ADDENDUM NO. 02

**High School Addition & Renovation
Jr. High Addition & Renovation
Intermediate School Controls Renovations
Primary School Controls Renovations
Softball Concessions
Ellettsville, IN 47429**

ADDENDUM NO. TWO

**Richland-Bean Blossom CSC
Additions and Renovations**

1 INTERIOR FINISH PLAN - FIRST FLOOR - UNIT B2

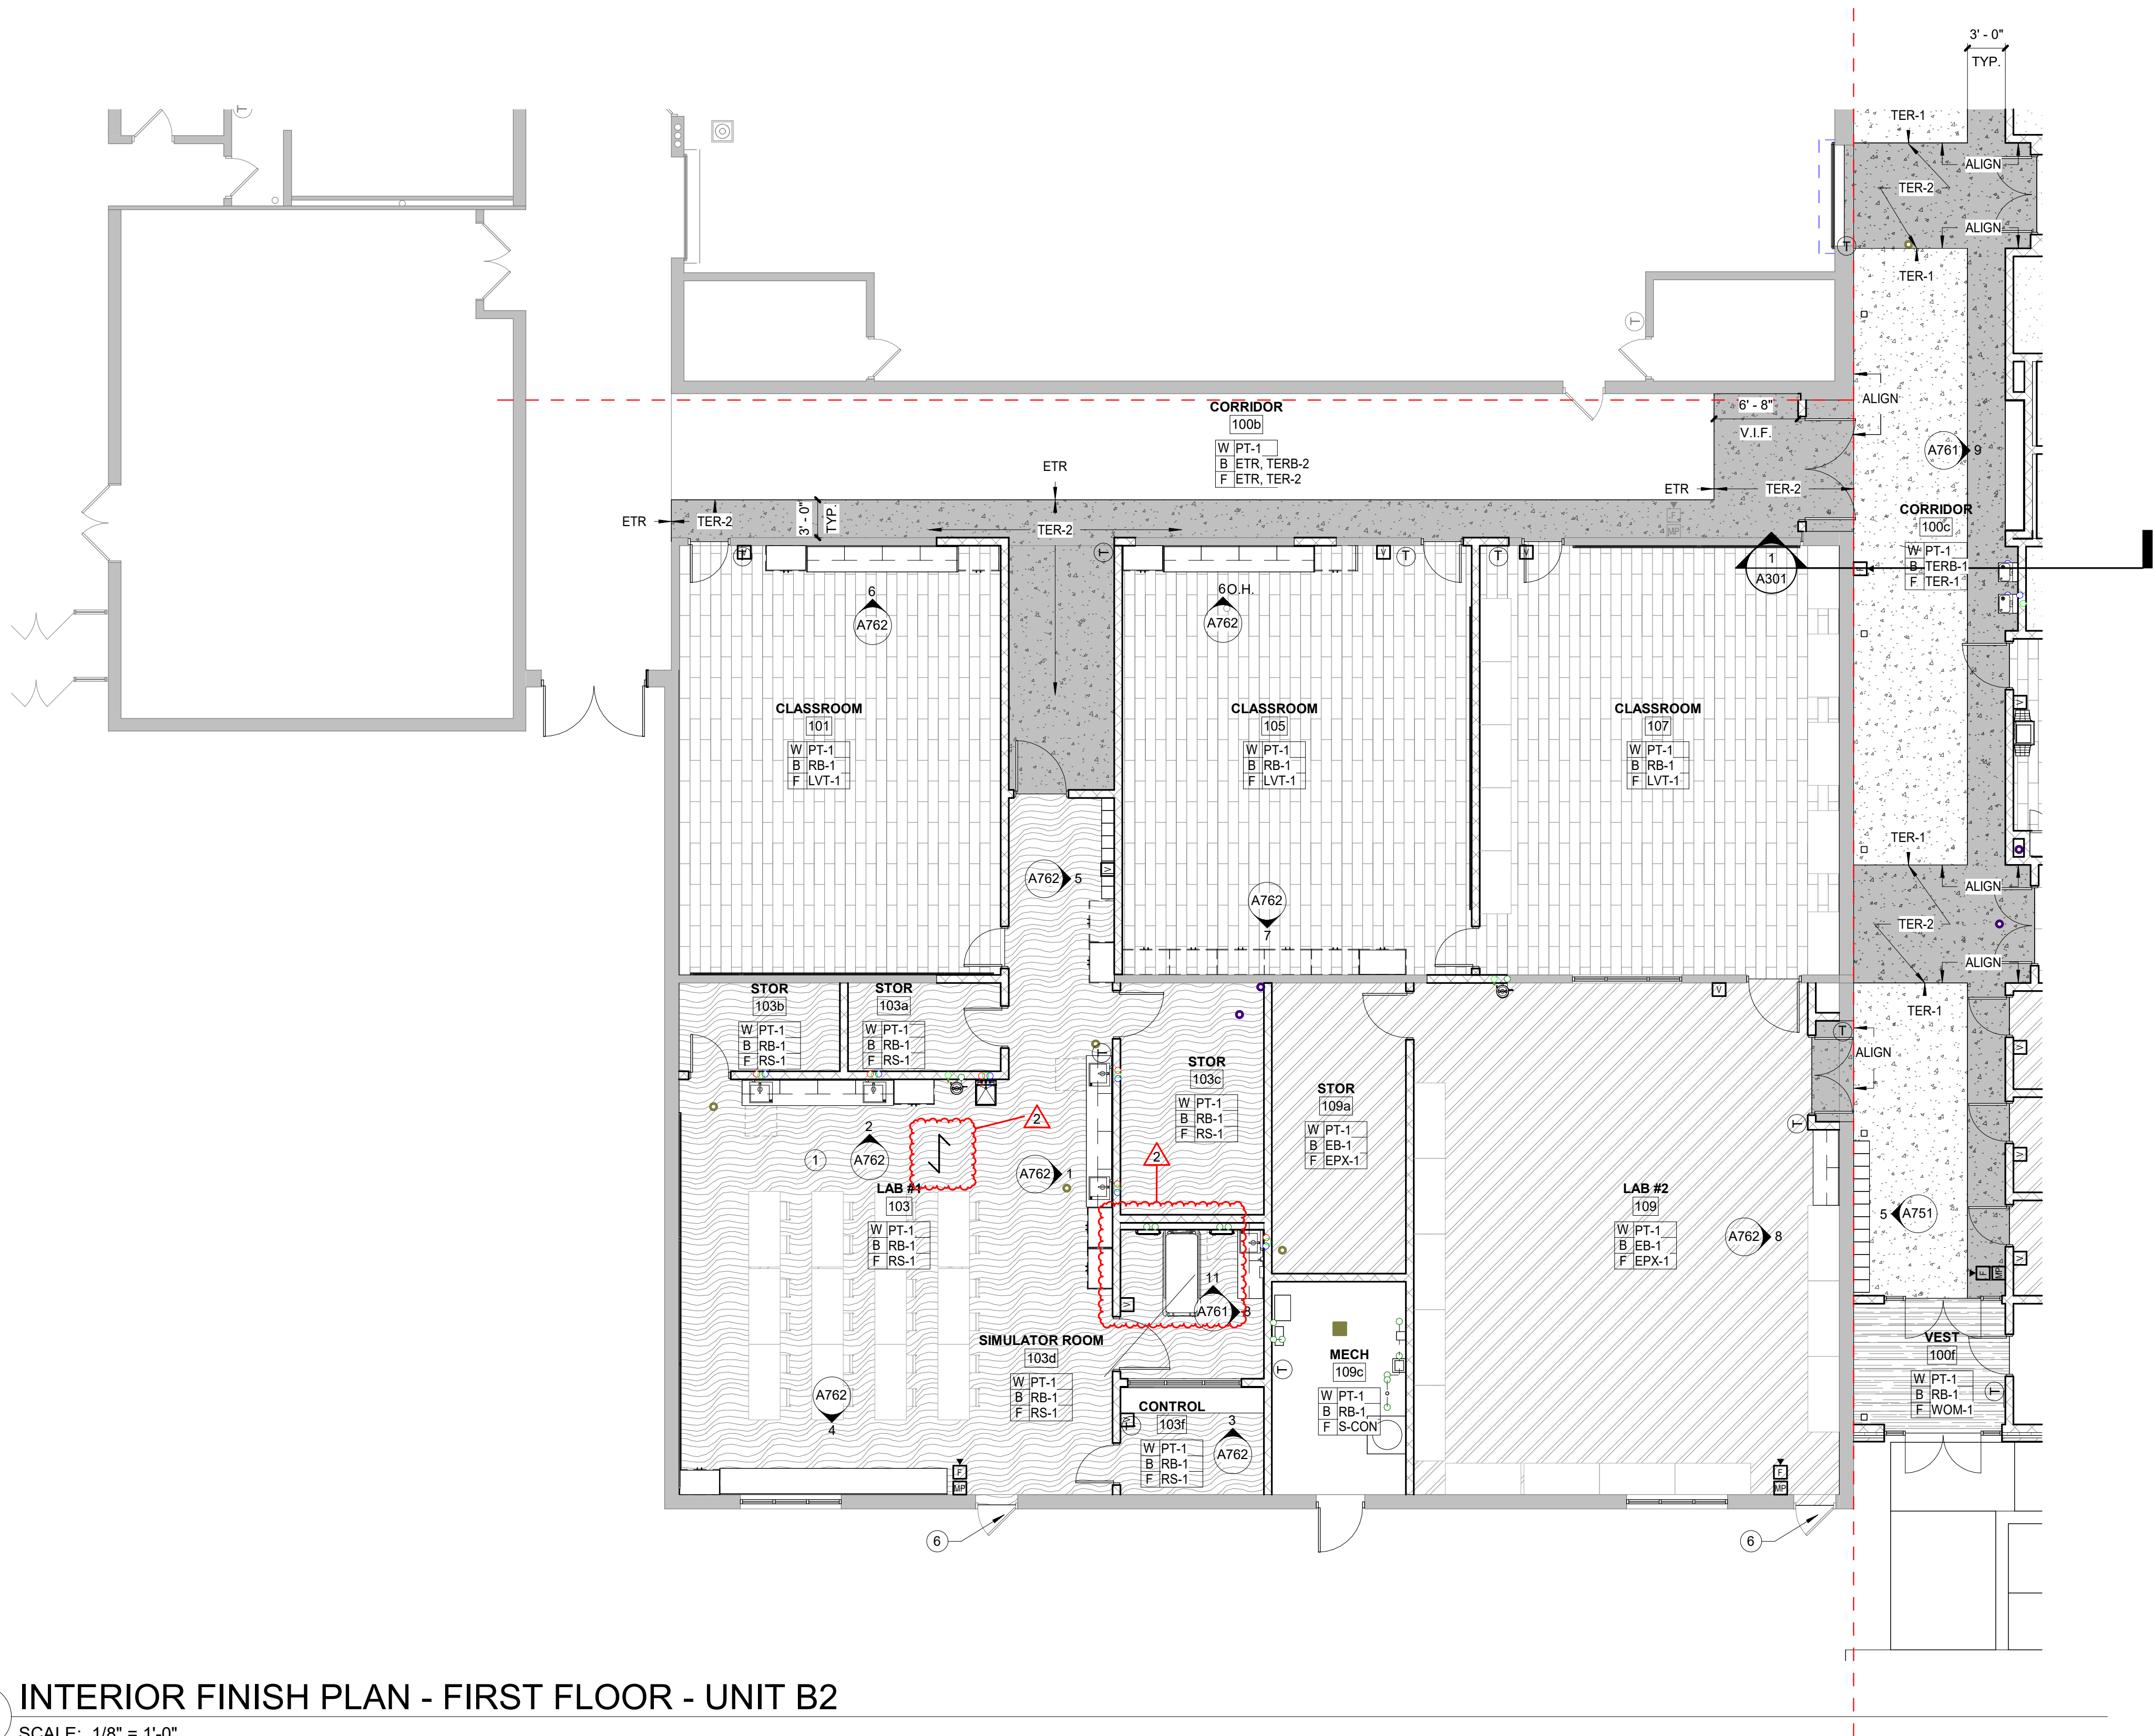
10. A721B2 – Interior Finish Plan – First Floor – Unit B2
 - a) Added flooring directional arrow in Lab #1 103.

- b) Revised north wall elevation, 11/A761 in Simulator Room 103d to show new material finish.

INTERIOR
FINISH PLAN -
FIRST FLOOR -
UNIT B3

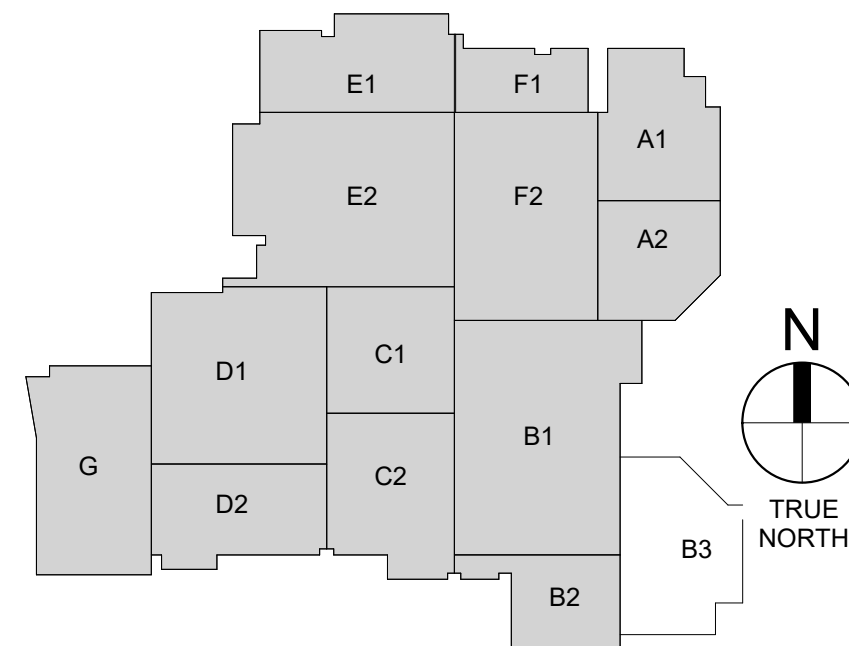
- a) Revised flooring in Band 106 and Choir 110 to show flooring accent change.
- b) Added flooring directional arrow in Band 106.
- c) Added casework elevations in Office 106j and Office 110e.
